Sumter City-County Planning Commission

December 19, 2012

MSP-12-54/HCPD-12-39, 649 W. Wesmark Blvd. – Lilavivat Medical (City)

File No. 01.4 Proposed Bldg
 Sheet **P-4** of 5

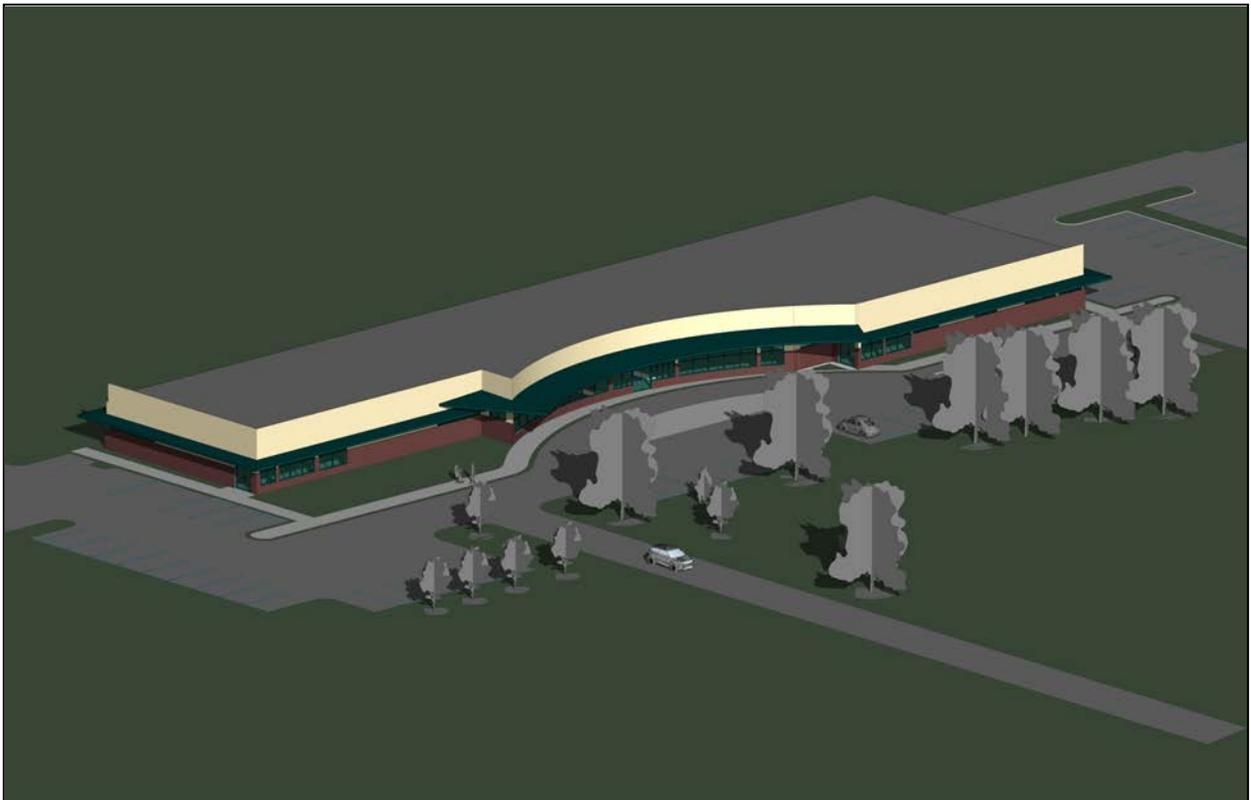
- a. If a new commercial building is proposed, not more than sixty percent (60%) of the facade facing a street may be glass or reflective materials;*

The proposed structure does not exceed the 60% threshold. Therefore it meets the requirements of this section.

- b. A minimum of eighty percent (80%) of the surface materials, excluding doors and windows, shall be brick, stucco, or stone masonry or materials approved by the Sumter City-County Planning Commission. Roof pitch should be compatible with the building structures in the surrounding neighborhood.*

The proposed structure is to be constructed of the following materials and appear as shown in the attached elevations prepared by Drakeford Architects and dated October 2, 2012:

- Brick
- Storefront Glass
- Stucco panels
- Flat Roof

The proposed structure is designed with over 80% of the recommended materials.

This project meets Highway Corridor architectural standards. Conceptual computer generated renders can be found on the following page:
